Comment #71 D2.1 (also address #46, #30)

Some updates are required for D2.1 to resolve issues rose during the discussions at September 2016.

Figure 33–39— I_{Con-2P} and $I_{Con-2P-usb}$ evaluation model

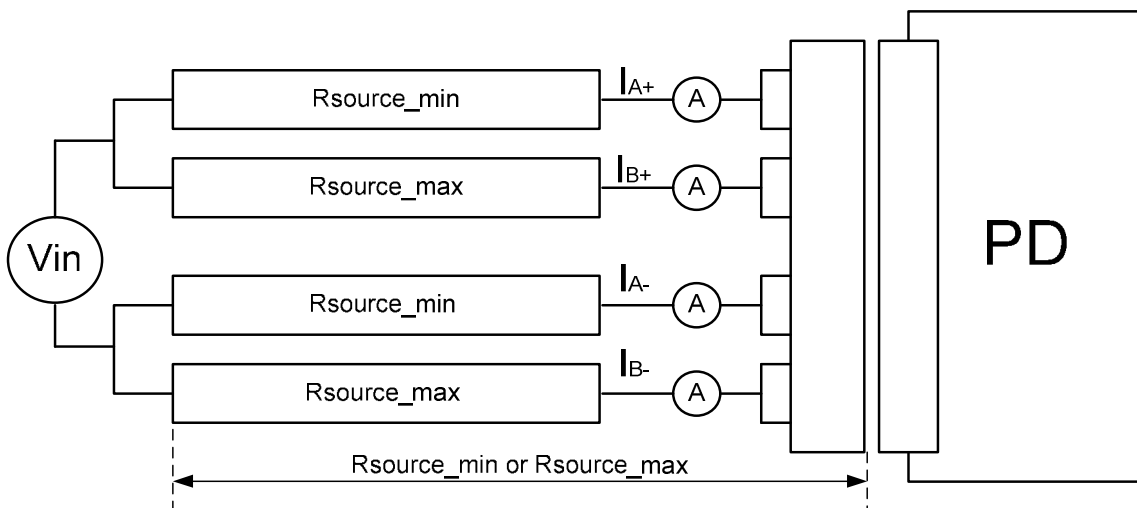
Mathematically, R_{source_min} and R_{source_max} is also a function that ties $R_{pair_PD_min}$ and $R_{pair_PD_max}$ to the system end-to-end unbalance. Therefore we make the below changes.

R_{source_min} and R_{source_max} represent the V_{in} source common mode effective resistance that consists of the PSE PI components ($RPSE_{min}$ and $RPSE_{max}$ as specified in 33.2.8.4.1, and $V_{Port_PSE_diff}$ as specified in Table 33–19, and the channel resistance, and [influence of \$R_{PAIR_PD_min}\$, \$R_{PAIR_PD_max}\$ specified in 33A.5 as function of system end-to-end unbalance](#)). Common mode effective resistance is the resistance of two conductors of the same pair and their other components, which form R_{source} , connected in parallel including the effect of the system total pair to pair voltage difference. I_A and I_B are the pair currents of pairs with the same polarity.

Figure 33B-1—PSE PI unbalance specification and E2EP2PRunb

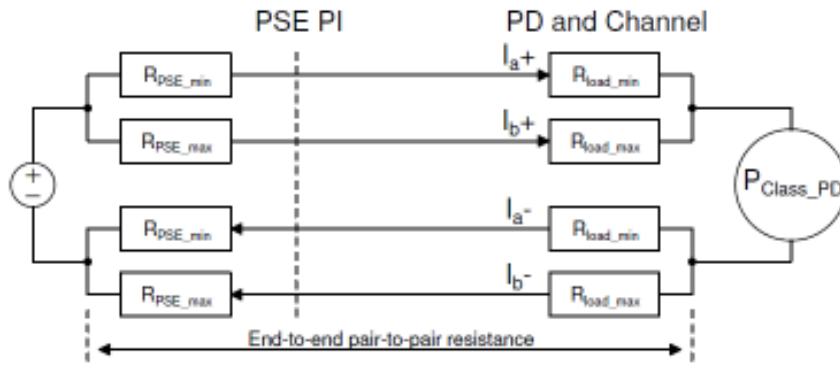
1. Resolving TDL for comment #78 D2.0 (Yair to align paragraphs above and below Figure 33B-1 to remove repetition. See comment 78 in D2.0)
 2. Updating 33B.4 to clarify its use.
 3. Updating figure 33B-2 for the location of VPort_PSE_diff.
 4. Other issues related to the changes made in the transition from D2.0 to D2.1.
- See updates to PSE-PD unbalance requirements in darshan_07_1116.pdf.

The following is response to TDL #78 to reduce duplication in the following 7 lines below.

Equation (33-15) is described in 33.2.8.4.1, specified for the PSE, assures that E2EP2PRunb will be met in the presence of all compliant, unbalanced loads (R_{load_min} and R_{load_max}) attached to the PSE PI. ~~a compliant 4-pair powered system.~~ Figure 33B-1 illustrates the relationship between effective resistances at the PSE PI as specified by Equation (33-15) and R_{load_min} and R_{load_max} as specified in Table 33B-1.

~~Equation (33-15) specifies the PSE effective resistances required to meet E2EP2PRunb in the presence of all compliant, unbalanced loads attached to the PSE PI.~~ There are three alternate test methods for R_{PSE_max} and R_{PSE_min} and determining conformance to Equation (33-15) and to I_{con-2P_unb} .

Figure 33B-2—Direct measurements of effective R_{pse_max} and R_{pse_min}

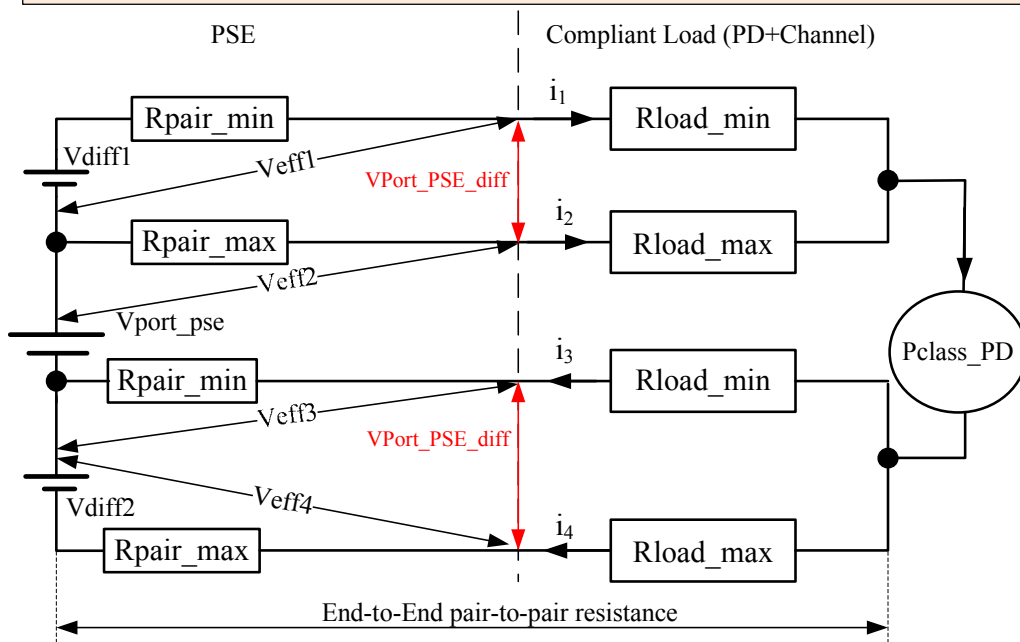
Update Figure 33B-2 as follows:

If there is access to internal circuits, effective resistance may be determined by sourcing current in each path corresponding to maximum P_{Class} operation, and measuring the voltage across all components that contribute to the effective resistance, including circuit board traces and all components passing current to the PSE PI output connection. The effective resistance is the measured voltage V_{eff} , divided by the current through the path e.g. the effective value of R_{PSE_min} for i_1 is $R_{PSE_min} = V_{eff1}/i_1$ as shown in Figure33B-2.

Figure 33B–4—Current unbalance test circuit

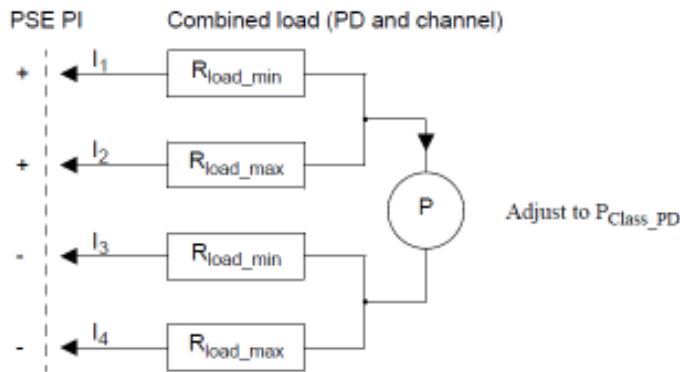
The above two lines were deleted since it is already specified above.

The following method may be used ~~if the internal PSE circuits are not accessible or~~ if the PSE is using active or passive current balancing circuitry that results in a variable effective resistance to control current unbalance. The current unbalance requirement shall be met for any pairs of the same polarity and with the load resistances per Table 33B–1. A PSE which uses current balancing methods which effectively using lower R_{PSE_max} than required by Equation 33-15 and meets Icon-2P_unb requirements, ~~the current unbalance measurement test~~ by definition also meets Equation (33–15). Figure 33B–4 shows a test circuit for the current unbalance requirements measurement.

~~Verification of I_{con-2P_unb} in step 6 and 7 confirms that PSE R_{pse_max} and R_{pse_min} are in conformance to this specifications.~~
